APPEAL SUMMARY

Appeal ID: 28236	Project Address: 1000 SW Broadway
Hearing Date: 2/1/23	Appellant Name: Nathan Morris
Case No.: B-012	Appellant Phone: 5037039875
Appeal Type: Building	Plans Examiner/Inspector: Geoffrey Pena
Project Type: commercial	Stories: 25 Occupancy: Mixed Construction Type: Tenant Improvement
Building/Business Name: 1000 Broadway / Northwest Children's Theater	Fire Sprinklers: Yes - 100%
Appeal Involves: Alteration of an existing structure	LUR or Permit Application No.:
Plan Submitted Option: pdf [File 1]	Proposed use: Theater Production House

Code Section OSSC 909 Smoke Control

1000 BROADWAY NW CHILDREN'S THEATER FIRE ALARM SYSTEM

FA-101

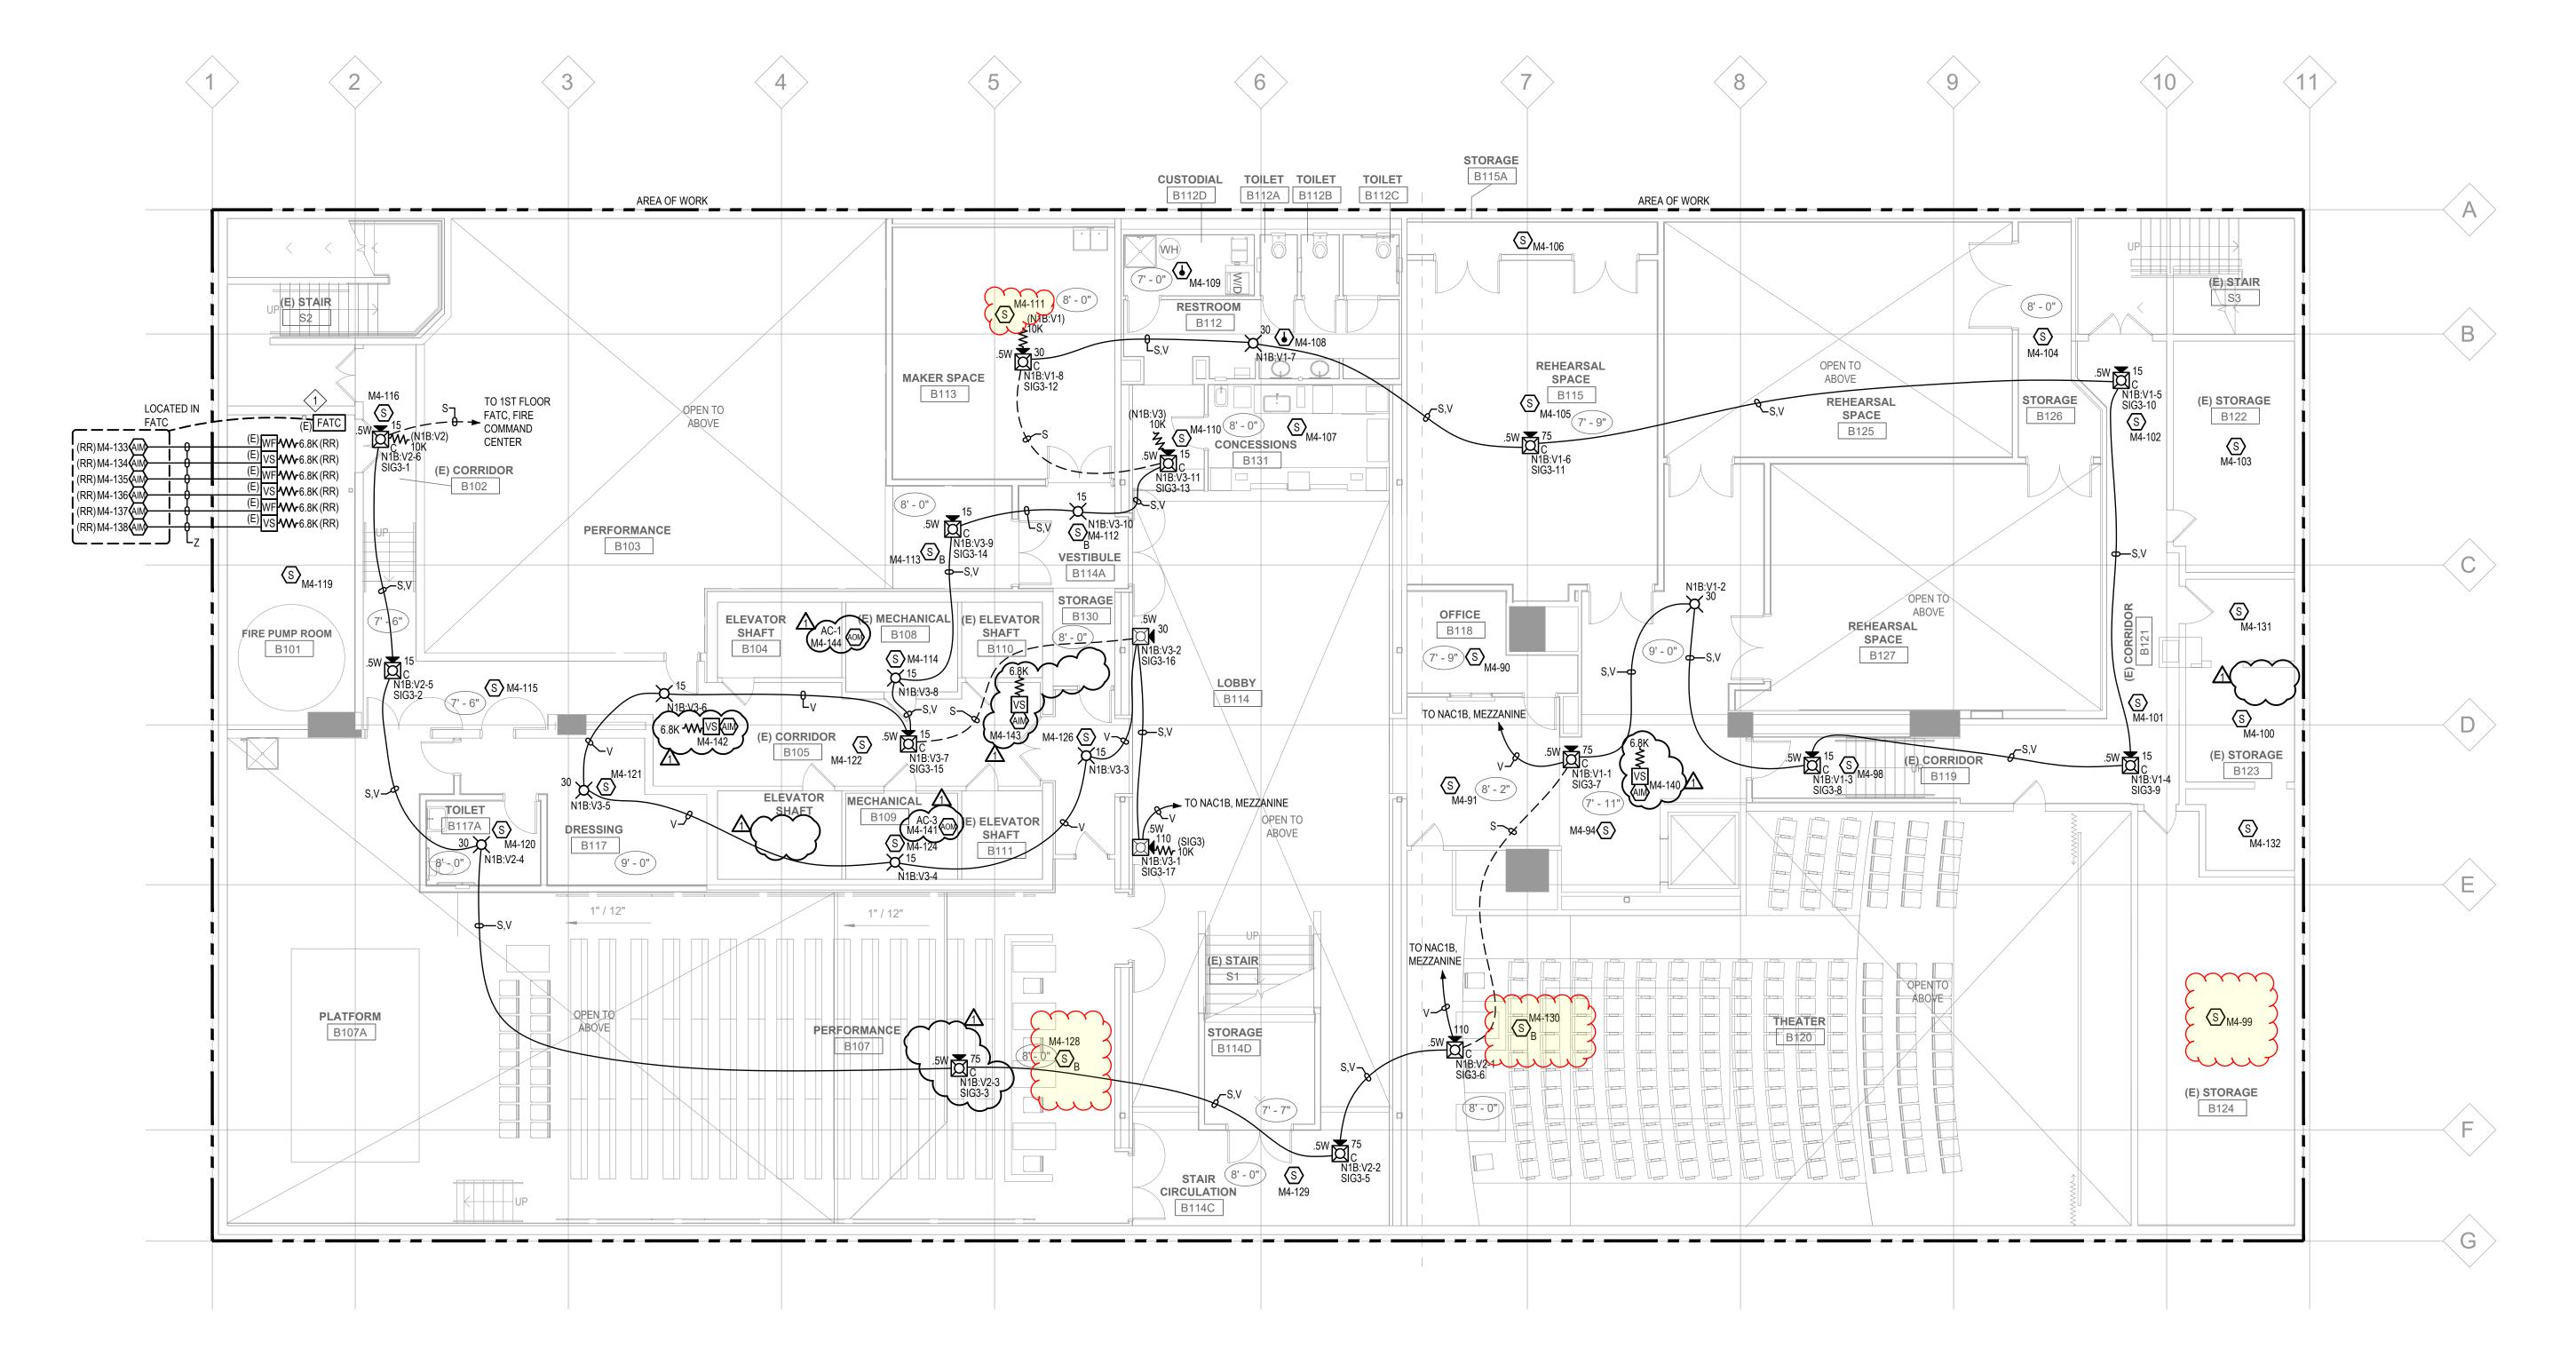
Code Modification or Alternate Requested We are requesting the ability to perform a manual bypass on a select few smoke detectors located in the Northwest Children's Theater during productions using theatrical fog.

Detectors effected by bypass.

The Administrative staff has reviewed your appeal regarding bypassing smoke detectors during a performance when theatrical fog is used and any smoke that is crated during the construction of stages. The fire code appeal is granted provided a fire department standby is present during performances and a fire watch is in place by your staff during construction activities.
